ADDENDUM NUMBER 02

DATE: 3/8/2023

PROJECT: MHS Band and Choir Renovation

PROJECT NUMBER: 22-1722

INTERIOR ELEVATIONS

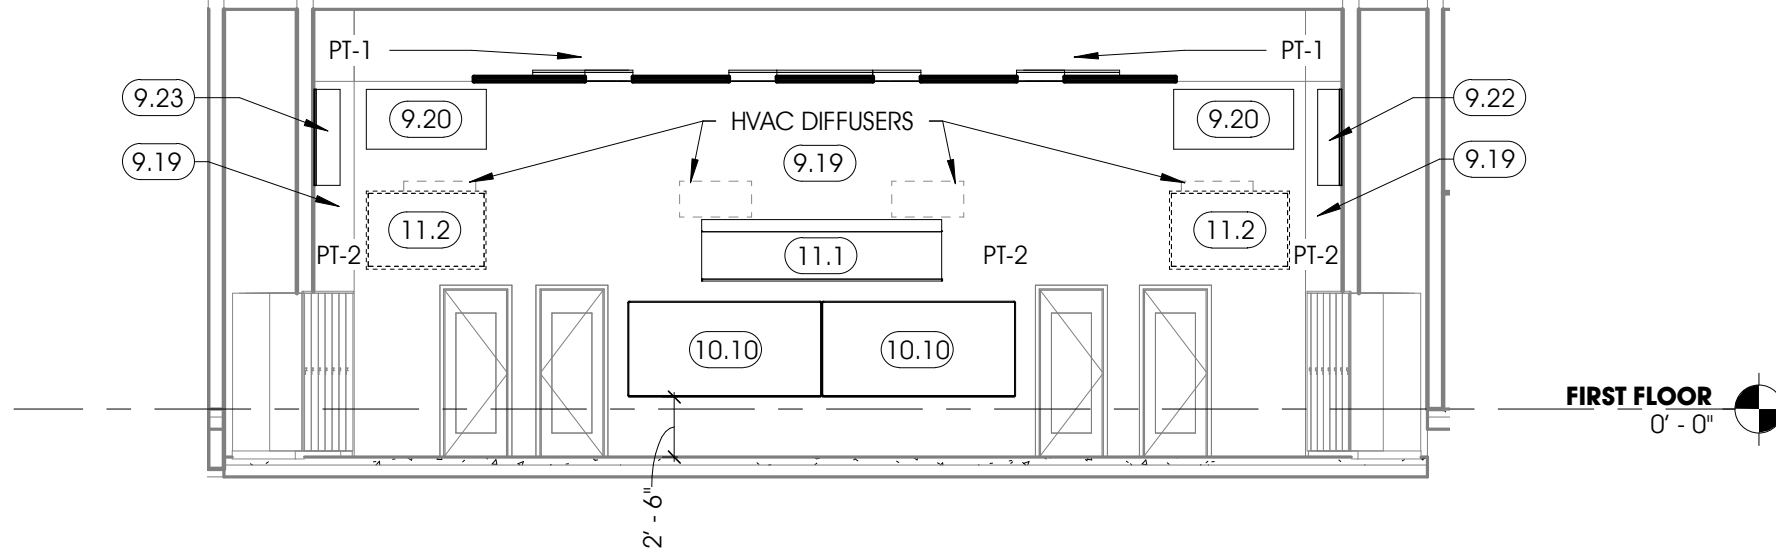
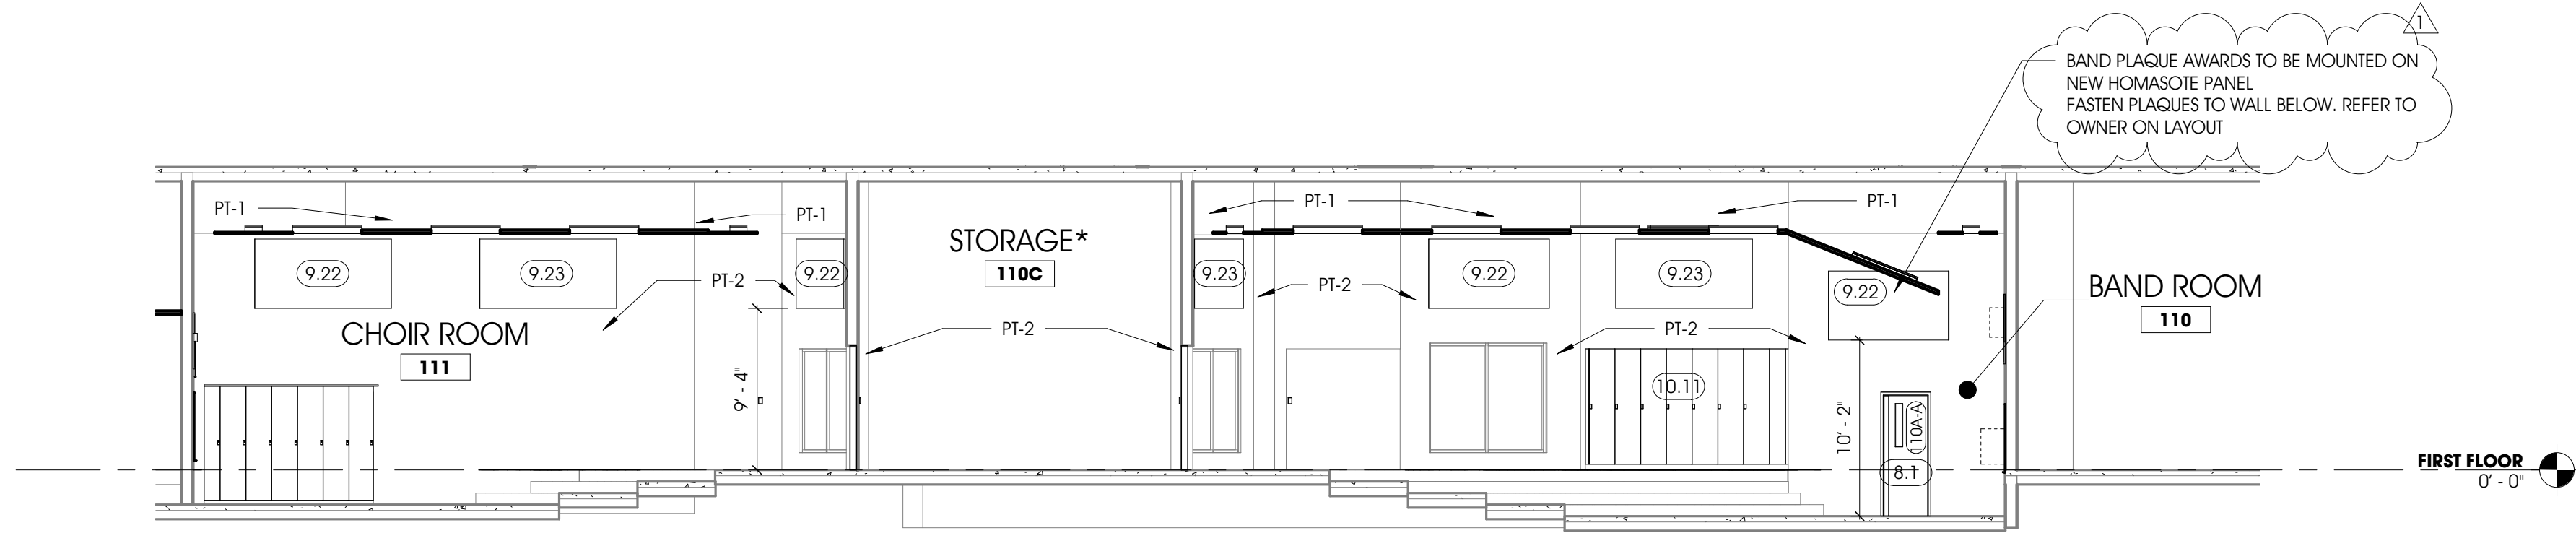
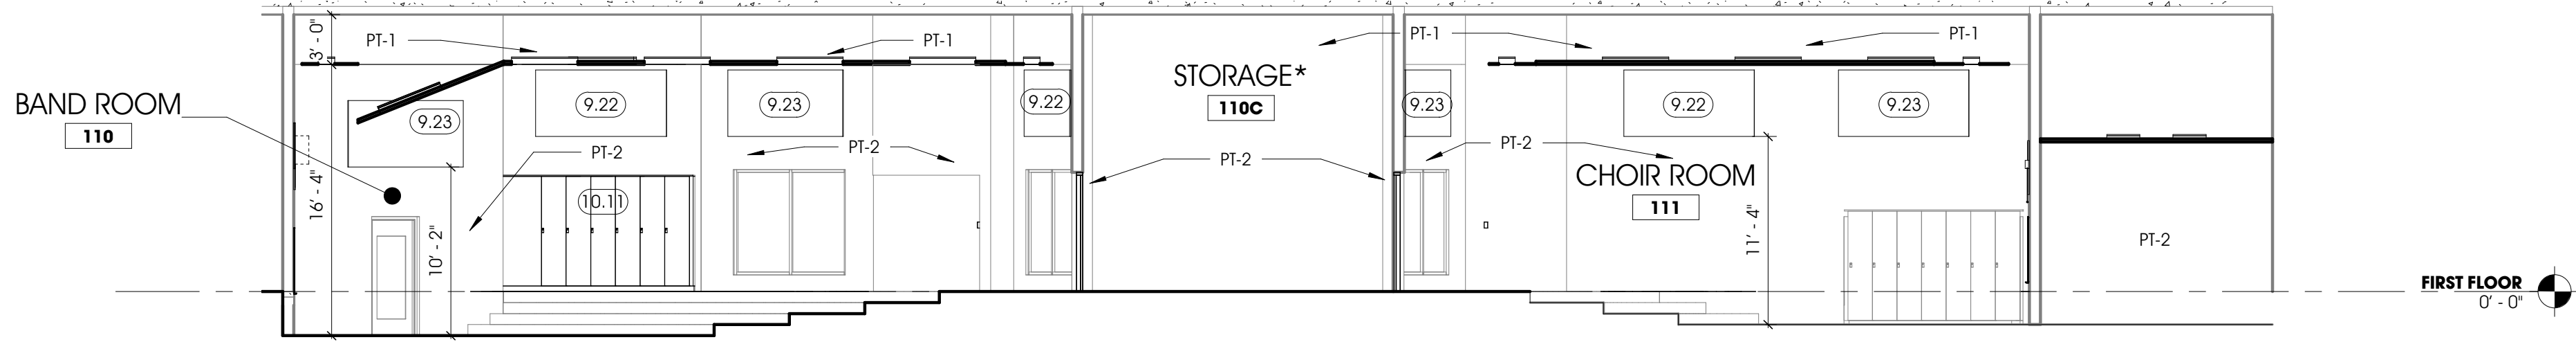
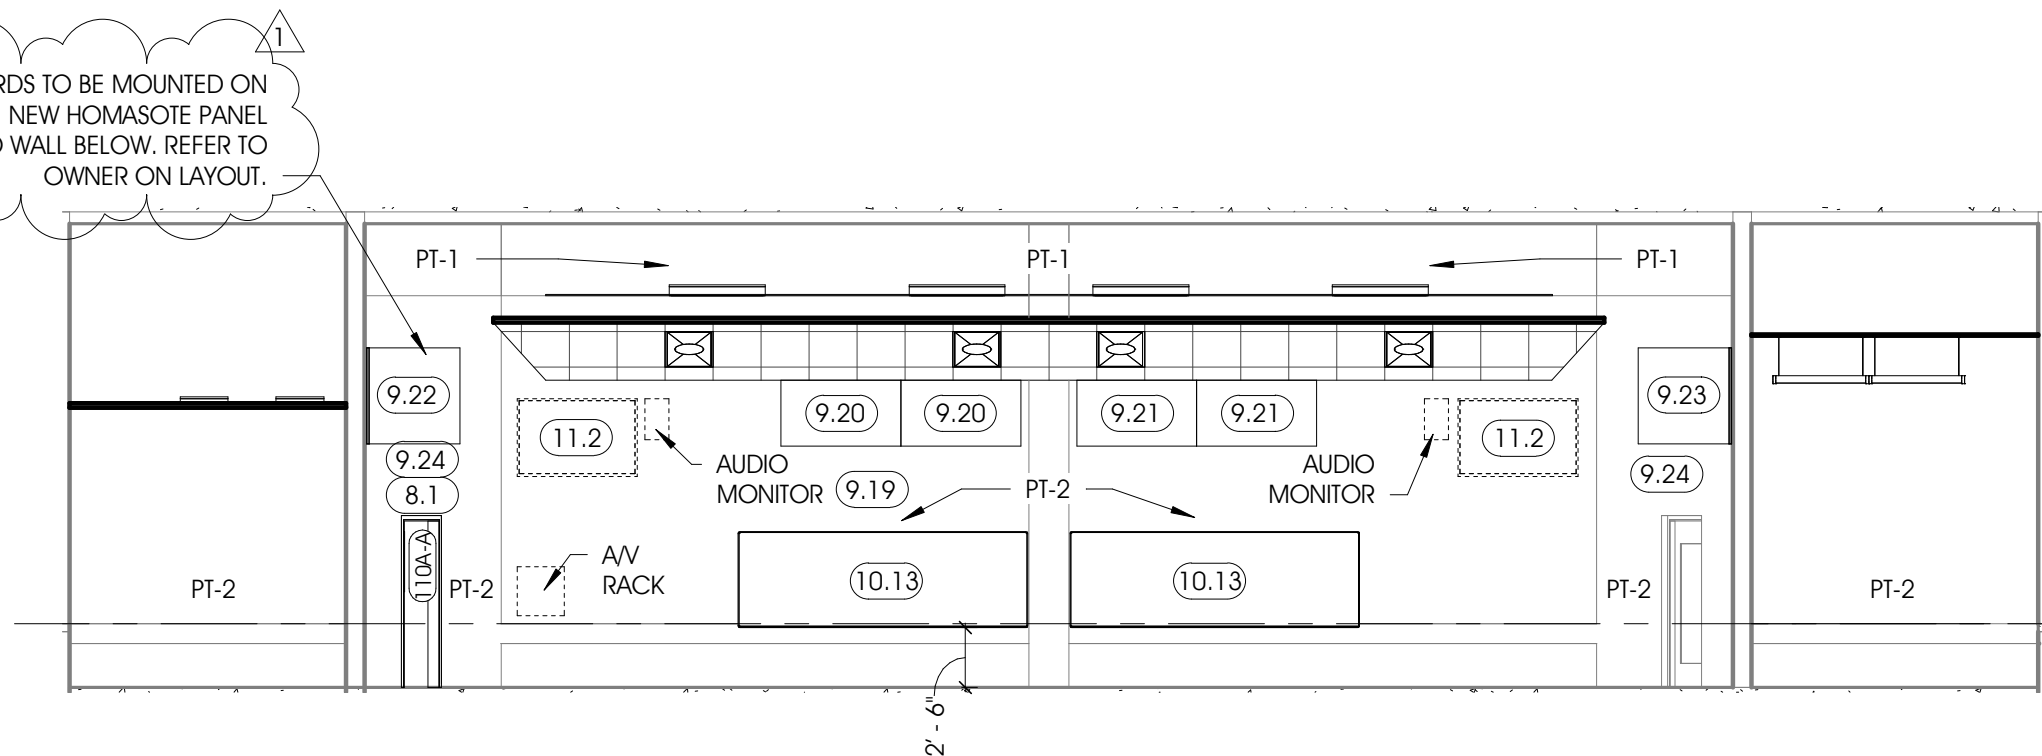
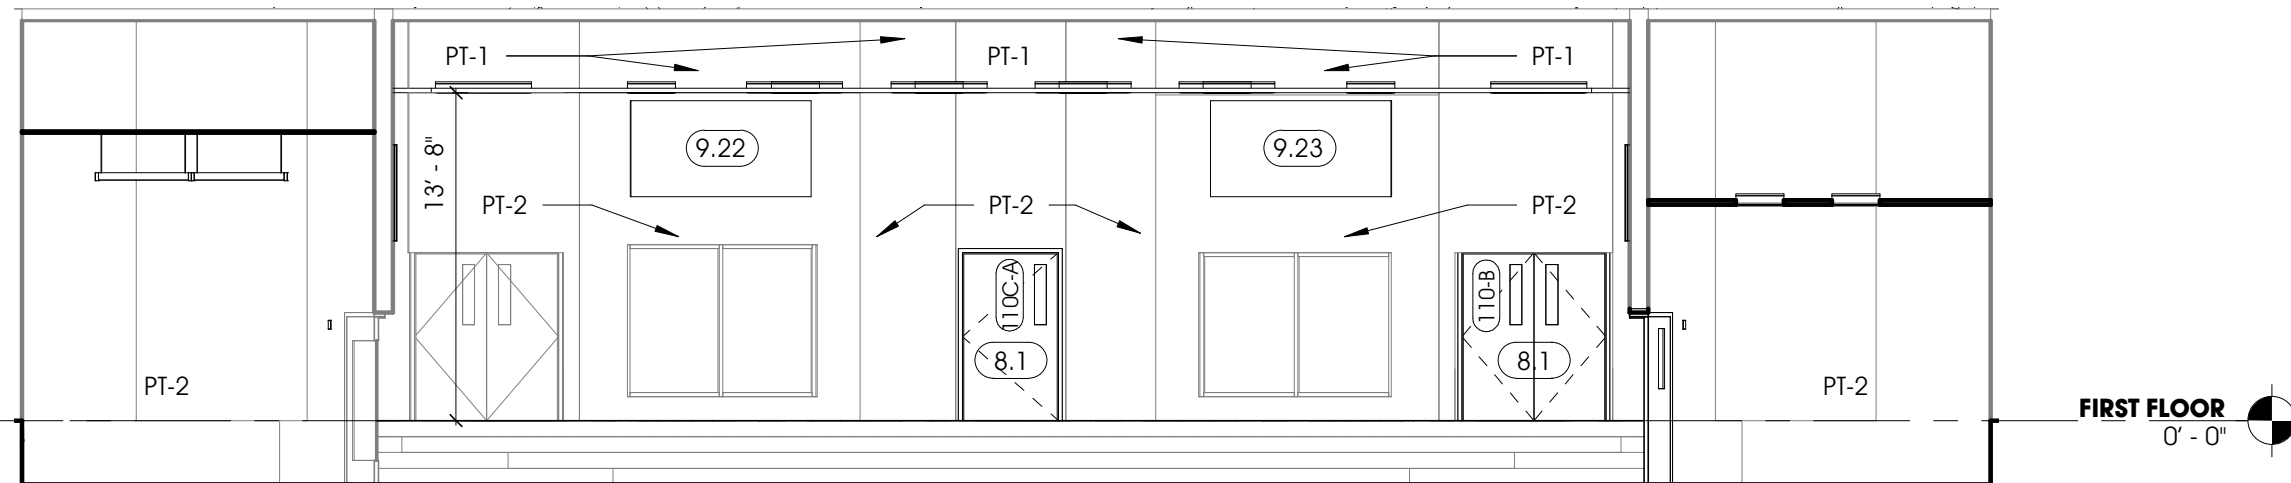
- 14) **MODIFY** leader note on new homasote panel to clarify band award plaque installation instructions.

DOOR ELEVATIONS

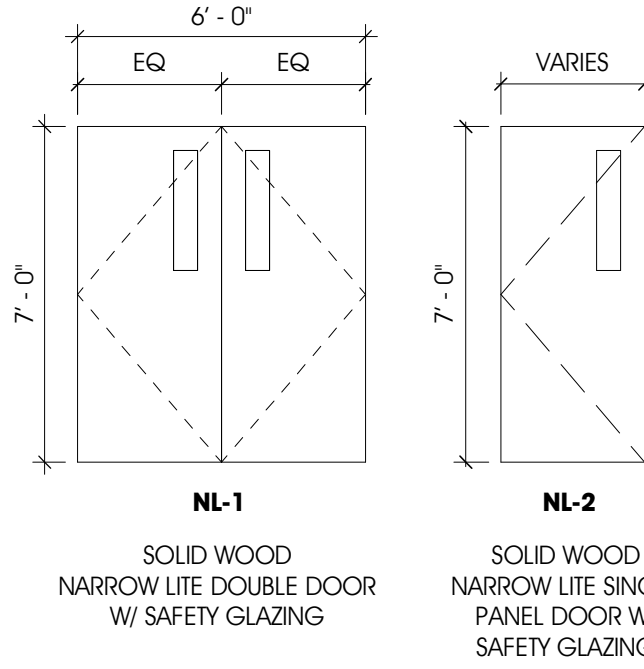
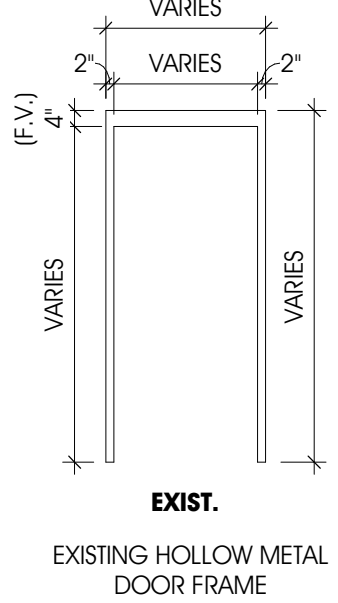
- 15) **MODIFY** door schedule to provide more clarity on door sizing, finishes & hardware.
- 16) **MODIFY** door schedule to show change of door sizes on doors 111-A & 111-B. This change will appear graphically on all other sheets.
- 17) **DELETE** door types, NL-2 & NL-3 from door elevations.

- 18) **DELETE** note J from General Notes – Finishes.
- 19) **DELETE** note C from DOOR & FRAME NOTES

- 21) DOOR & FRAME NOTES – Note B - where does this start and stop?
 - a) Refer to modified door schedule.
- 22) DOOR AND FRAME NOTES – Note C - are we providing a Knox Box?

- a) No Knox box is needed for this project.
- 23) DOOR AND FRAME NOTES – Note E – Drawing T1.2 does not exist.
 - a) Remove note E on DOOR AND FRAME NOTES. Drawing T1.2 is not needed.

- 24) DOOR SCHEDULE – Frame Finish tells us to reference General Note H.
 - a) DOOR SCHEDULE is now modified for clarification. Reference Sheet A9.1
- 25) GENERAL NOTES – DOORS – NOTE A – If door hardware is found to be damaged will a CO be required?

- a) Yes, if hardware on doors that aren't being replaced are found to be damaged a CO will be required.
- 26) GENERAL NOTES – DOORS- NOTE B – Did you specify soundproof doors?

- a) No, there will not be a required STC rating for the doors in this project. Hardware will be added to new doors to address sound transmission. Reference Sheet A9.1 for hardware information.
